Staff Report to the Zoning Administrator

Application Number: 251461

Applicant: Trevor Schur
Owner: 880 41st OZ LLC
APN: 033-141-30
Site Address: 880 41st Avenue, Santa Cruz

Project Description: Proposal to construct a 10-unit mixed-use development in two structures on a vacant parcel. Proposal includes 9,875 square feet of gross floor area, comprised of 8,211 square feet of residential space, 675 square feet of commercial space, and 989 square feet of bicycle storage, trash, and utility areas. The proposal includes a request for a residential Density Bonus to provide two affordable units in exchange for two concessions and waivers to site standards for mixed-use development. The project requires a Conditional Use Permit (CUP) for residential development in the C-2 zone district, an Administrative Site Development Permit (ASP) for residential site development, and a Coastal Development Permit.

SIGN AREA: 15 SF
WALL MOUNTED

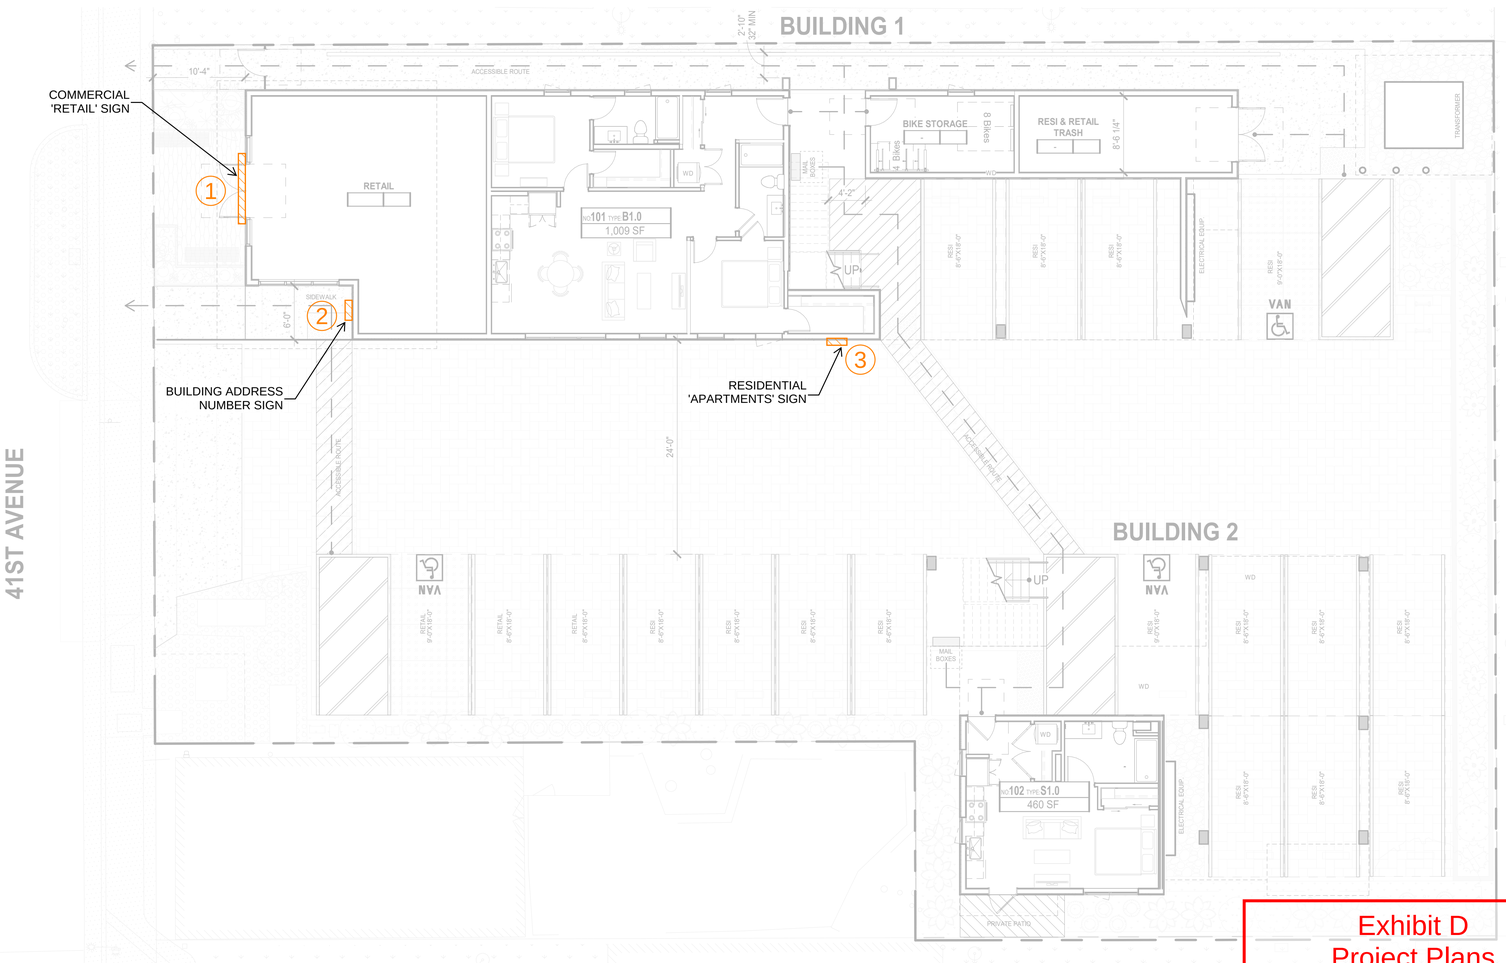
2. Signage associated with the business shall be limited to no more than 15 square feet, directly above the doorway fronting 41st Avenue, consistent with the design on Sheet AP4.03 of the project plans (Exhibit D). Additional signage including window signs and freestanding signs may be permitted consistent with the requirements of the applicable County sign regulations.

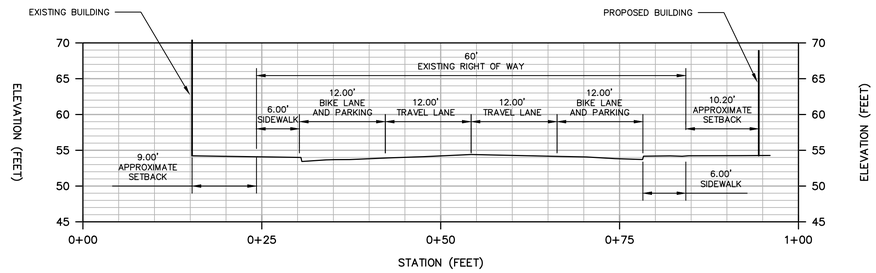
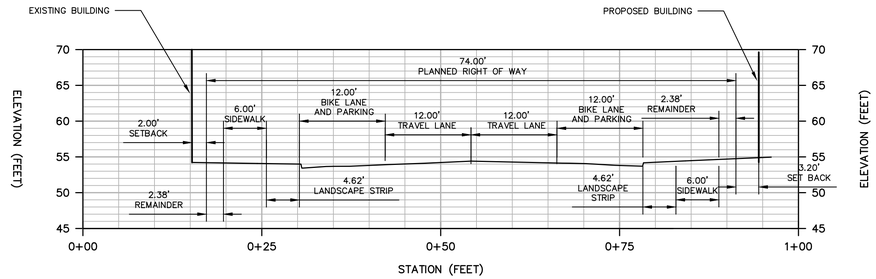
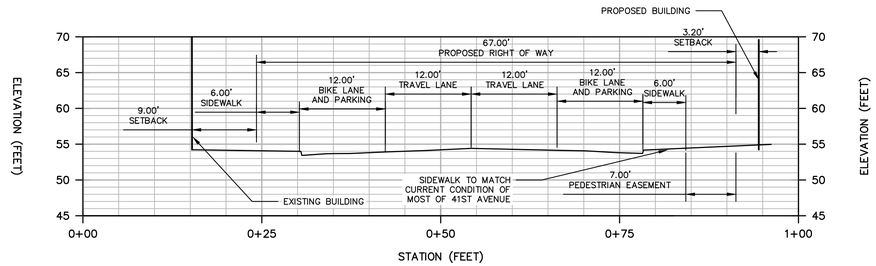
b. Provide a legend on the site plan sheet C2.0 that describes all

proposed surfacing types. Provide a different hatching for the pervious paver and precast porous concrete panels.

REV 5/19 FIG. SWM-9

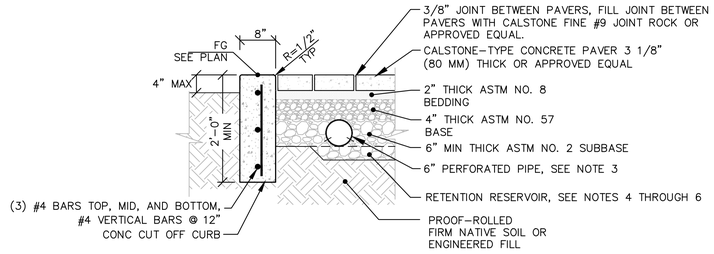
k. Include details for the tie-in to the existing system in 41st Avenue. Include Fig. SWM-9 for the tie in detail. Identify other utilities in the area and demonstrate adequate separation from the proposed storm drain.

3 C3.1 PERVIOUS PAVER SECTION

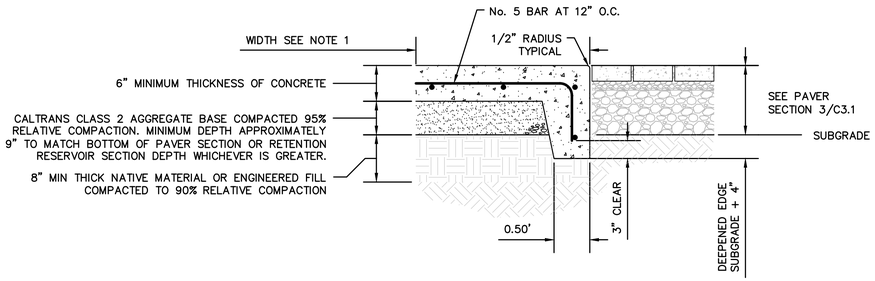
h. Provide updated details 3/C3.1 to include surface infiltration testing of the pavers; include specific test method and minimum acceptable rate to be demonstrated prior to construction final. There will be a hold on the building permit for this testing.

NORTHERN STORM DRAINAGE PROFILE

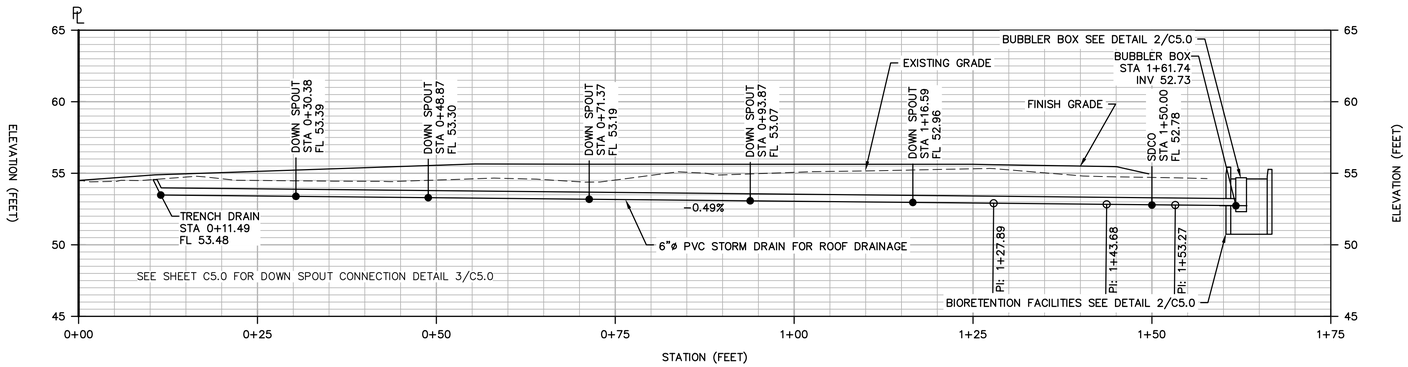
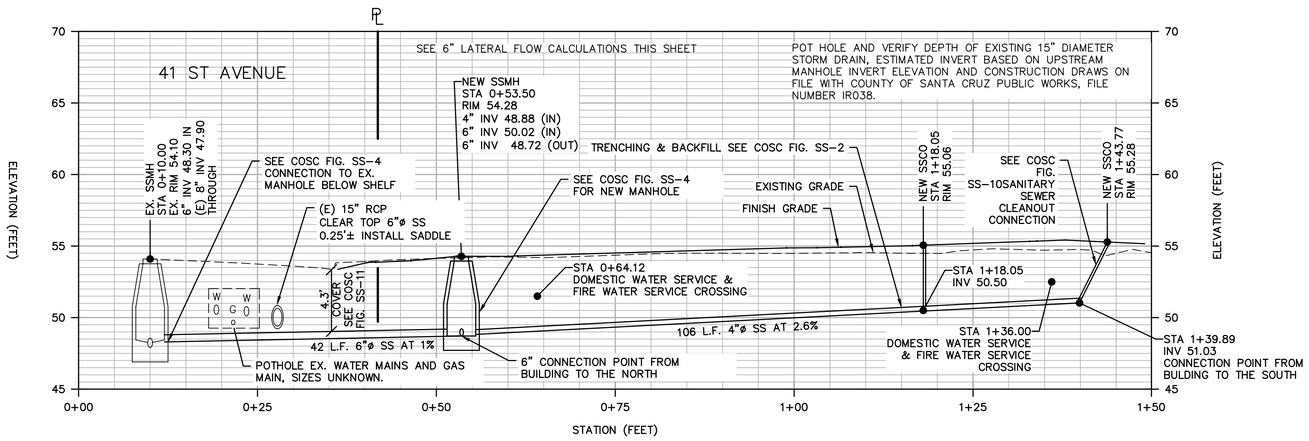
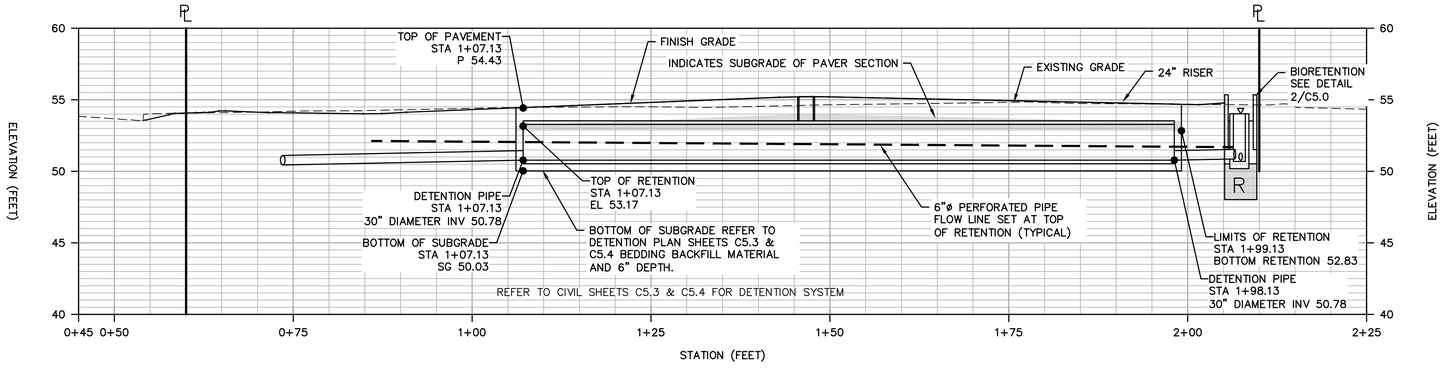
j. Update the plans for consistency with pipe sizes, types (should the north system profile on C4.1 be called out as a trench drain) and surface elevations (bioretention top of media elevation is different on C4.0 and C6.0).

2 C5.0 TYPICAL BIORETENTION FACILITIES

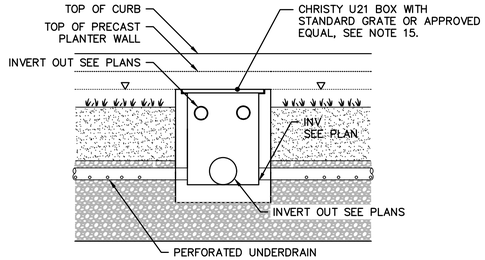
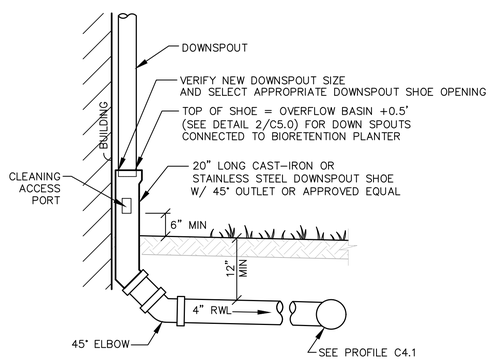
d. There are references to detail 7/C5.0 and 2/C5.0 for the bubbler boxes, but they are not provided. Please provide a detail for the V05 bubblers. The system/s shall include provisions to drain standing water in the pipes from the downspouts and trench drain so as not to cause vector issues.

g. Provide updated detail 2/C5.0 for infiltration testing at the bottom of the rock retention reservoir. Specify the test method to be used and the design infiltration rate to be demonstrated. There will be a hold on the building permit for submittal of this in-situ testing.
